Service Letter

58-G-18

1958 Thunderbird miscellaneous items

REAR SUSPENSION NOISE

Fig. 1 - Rear Suspension - Noise Correction

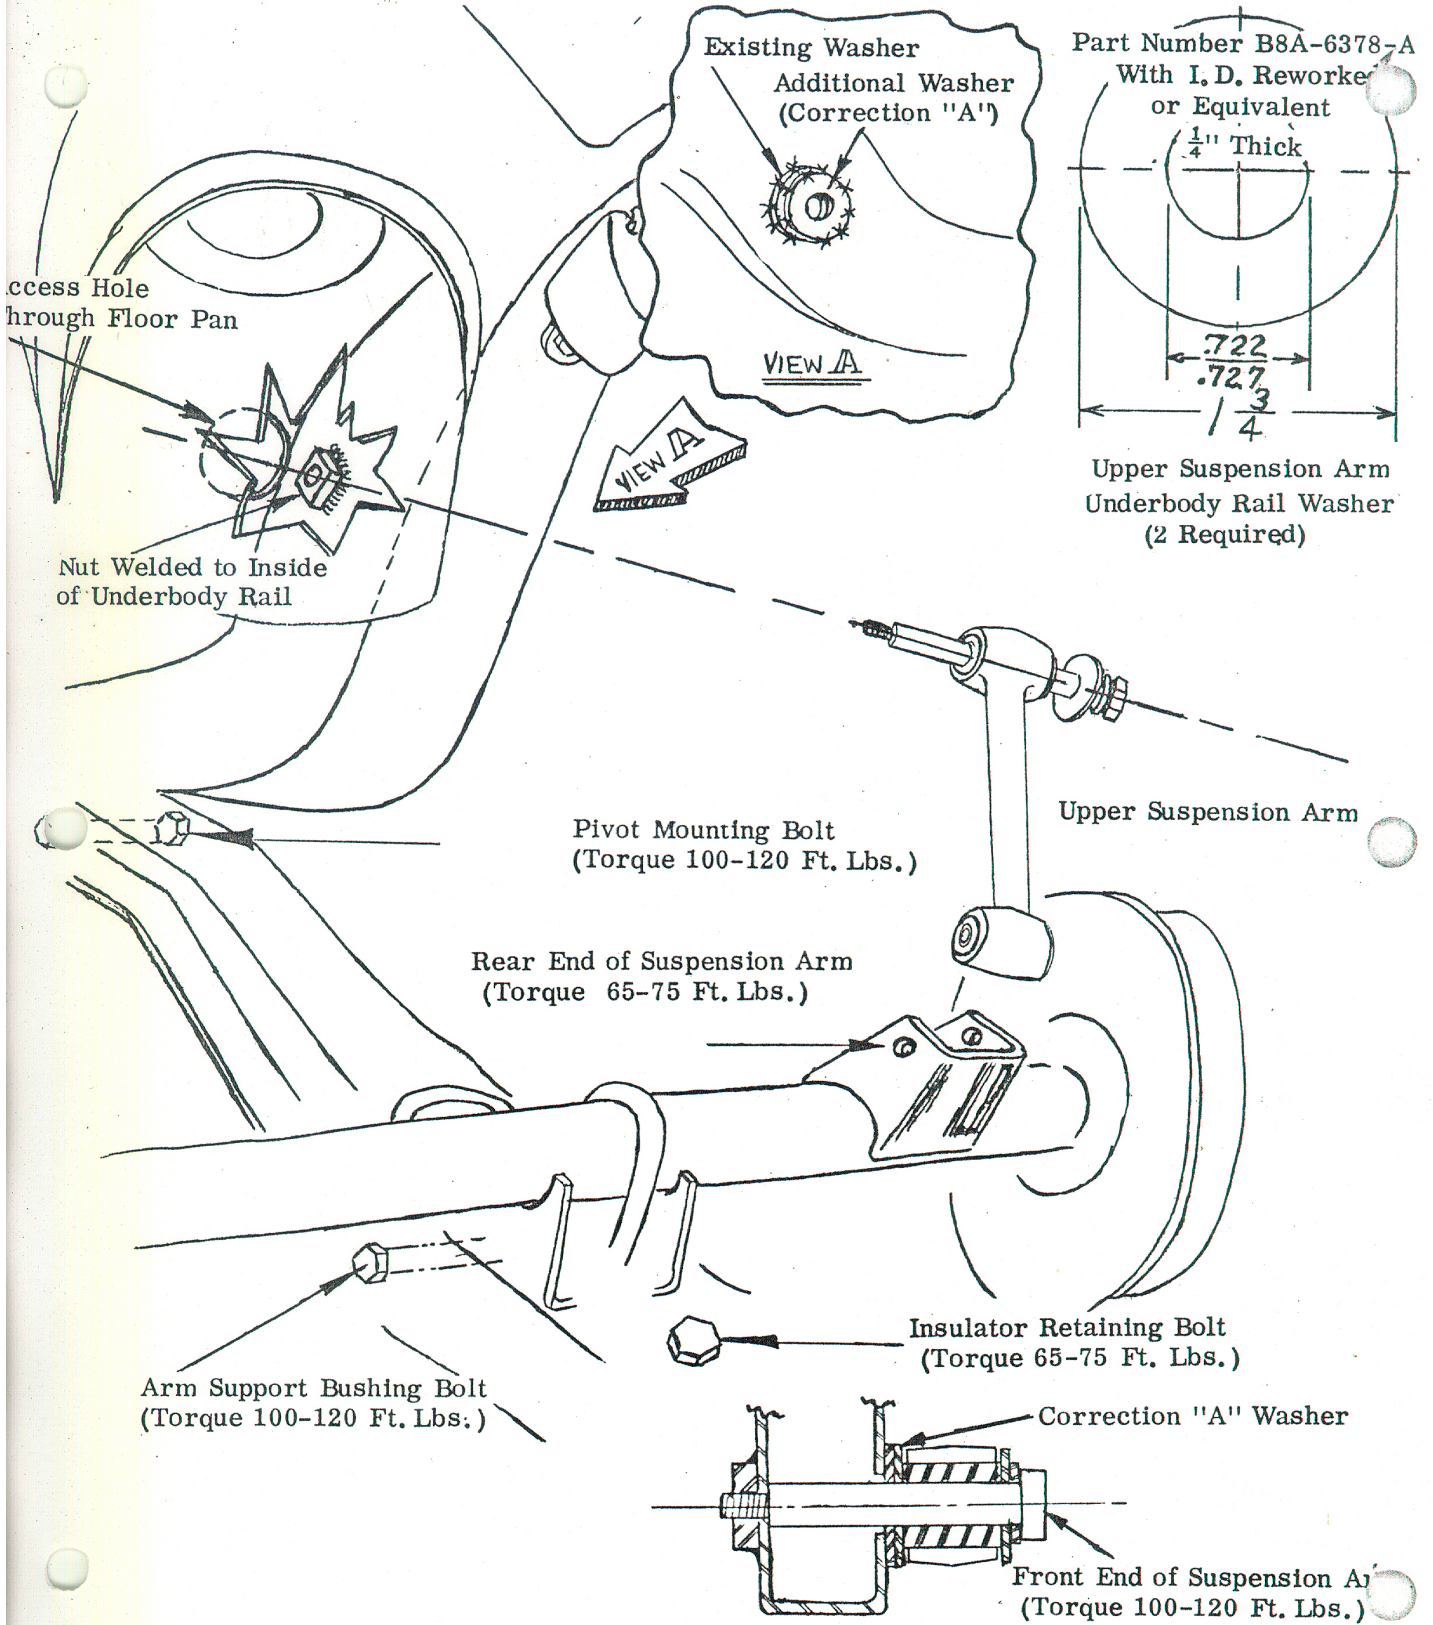
When rear suspension noise problems are encountered, the rear suspension members should be torqued to the revised torque specifications as shown in Figure 1. In those cases where this retorquing operation does not eliminate the noise, and the noise is attributed to the upper suspension arm, the arm and attaching parts should be reworked as follows for the conditions which are found to exist.

CORRECTION (A) EXCESSIVE CLEARANCE BETWEEN FRONT UPPER SUSPENSION ARM MOUNTING BOLT AND OUTSIDE UNDERBODY RAIL.

4. Position reworked flat washers—B8A-6378-A over existing washers. See Figure 1. Insert bolts through washers into nuts to align washers for welding. Weld washers to underbody rails and remove bolts.
5. Remove wet asbestos packing from left underbody rail and clean welded areas as required.
6. Install the arm and bushing assemblies (front bushing first) to underbody rail, then substitute (2) 34853-S7 split type lock washers for the star type washers removed.
7. Connect arms to axle brackets, secure with bolts, then torque front bolts to 100-120 ft. lbs. torque, and rear bolts to 65-75 ft. lbs. torque.
8. Torque all remaining rear suspension bolts to revised torque specifications (See Figure 1) and remove support jack from beneath rear axle.
9. Install wheel and tire assemblies and lower car to floor.

Figure 2 - Fix for Stripped Threads or Loose Nut

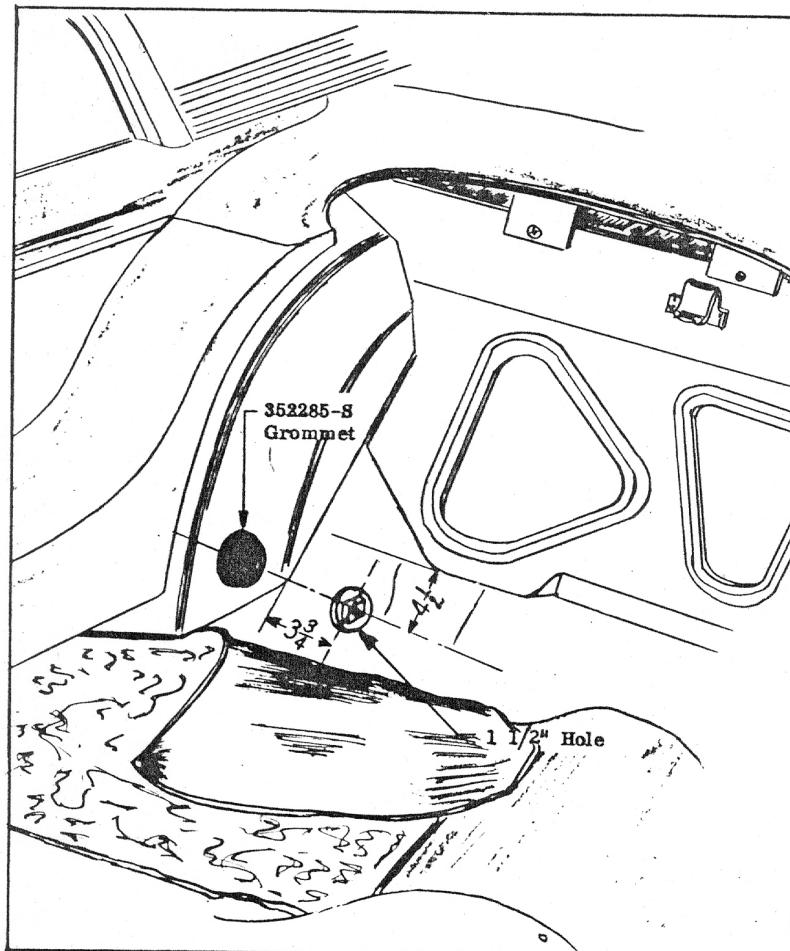
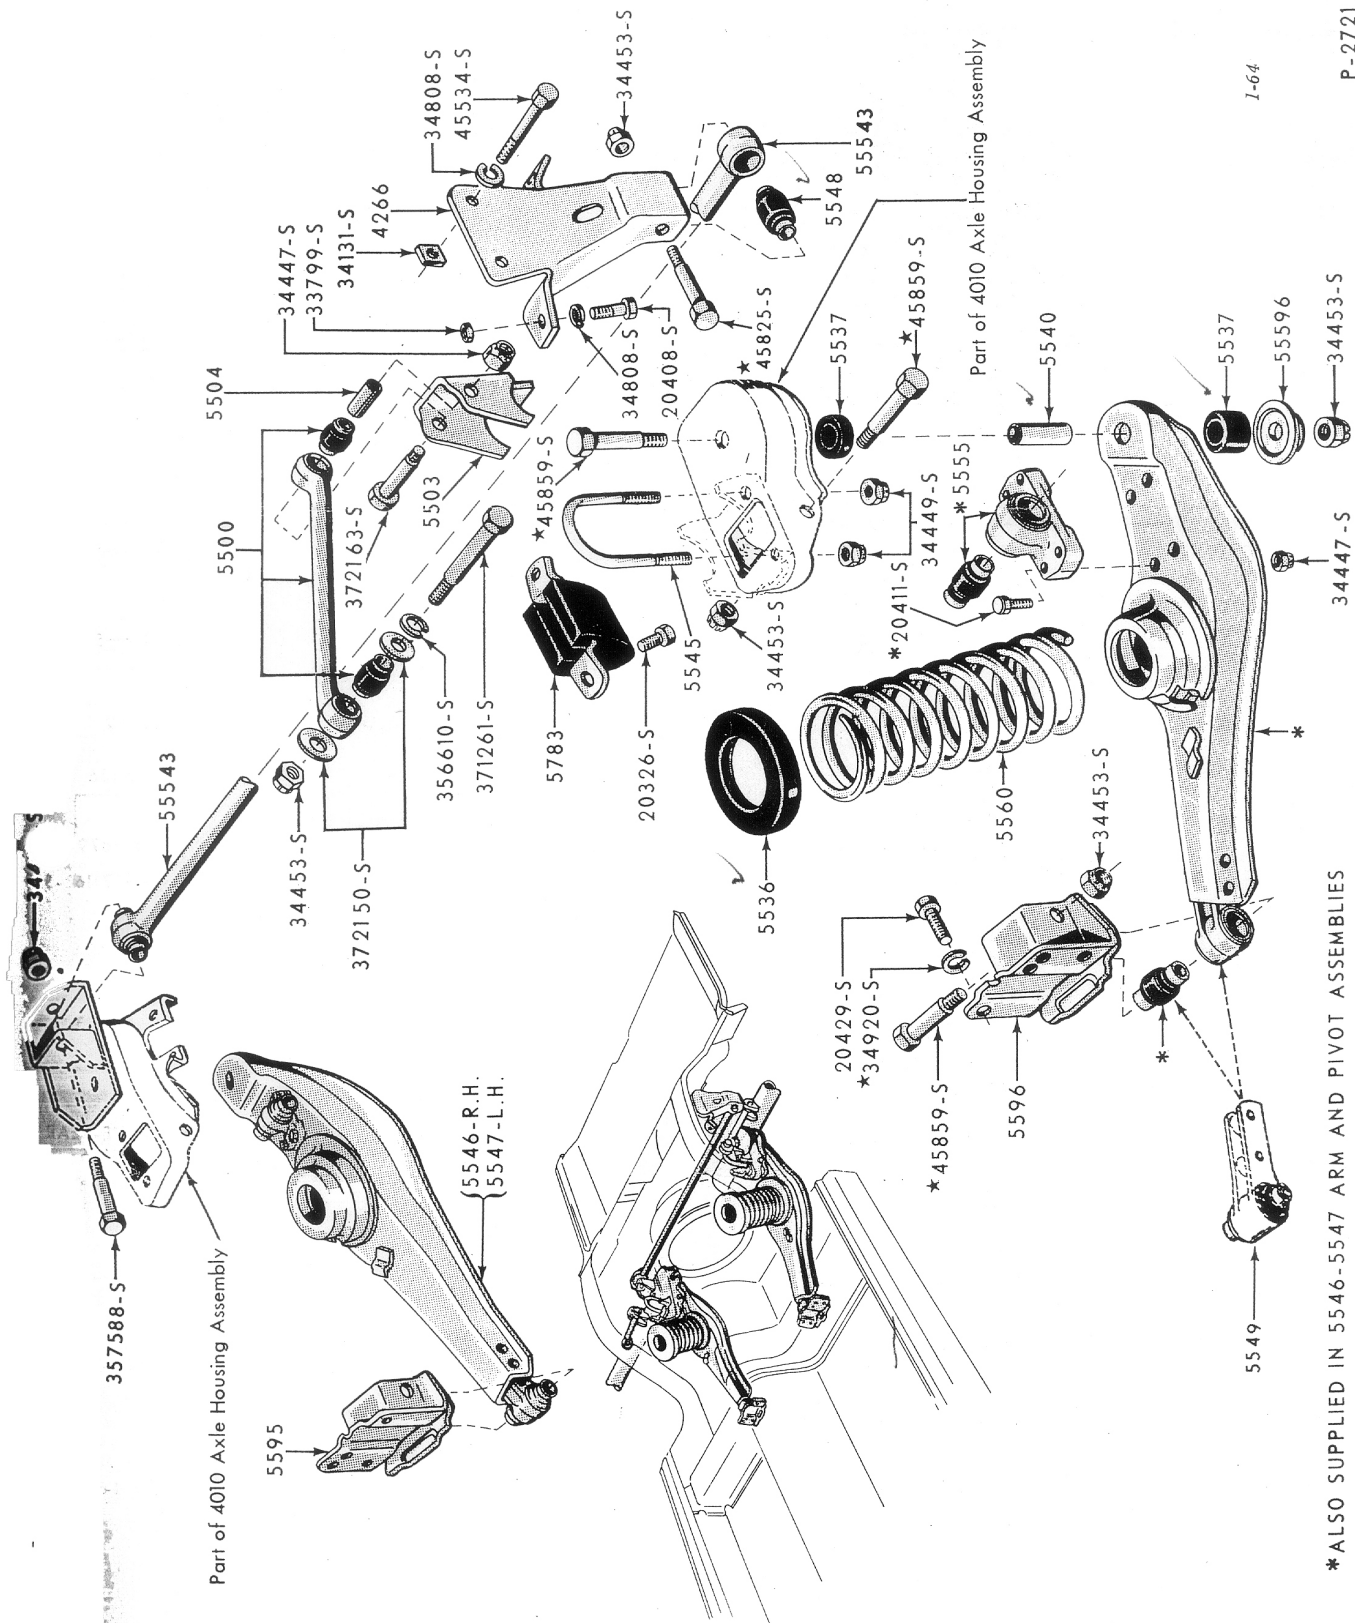
**CORRECTION (B) STRIPPED THREADS—
UPPER SUSPENSION ARM FRONT MOUNTING
NUT**

1. Remove the rear seat cushion and rear seat back assemblies, then locate and drill a 1½" diameter hole (See Figure 2).
2. Raise rear of car and remove rear tire and wheel assemblies then remove the bolt from the forward upper arm bushing.

3. Drill through the existing nut with a ¼" drill then split the nut with a chisel and remove from underbody rail. (Remove pieces of nut from spring pocket area with a magnet.)

4. Re-assemble the front bushing and bolt assembly (discard the star type lock washer and substitute a spring type ¾" lock washer).
5. Grind or file weld flash from inboard side of underbody rail then place a ⅝"-18 nut in the access hole.

6. Tighten the bolt to secure the nut, then arc weld the nut to the frame side rail.
7. Torque bolt to 100-120 ft. lbs.
8. Install grommet part number 352285-S in the drilled access hole then reinstall the seat back and seat cushion assemblies.
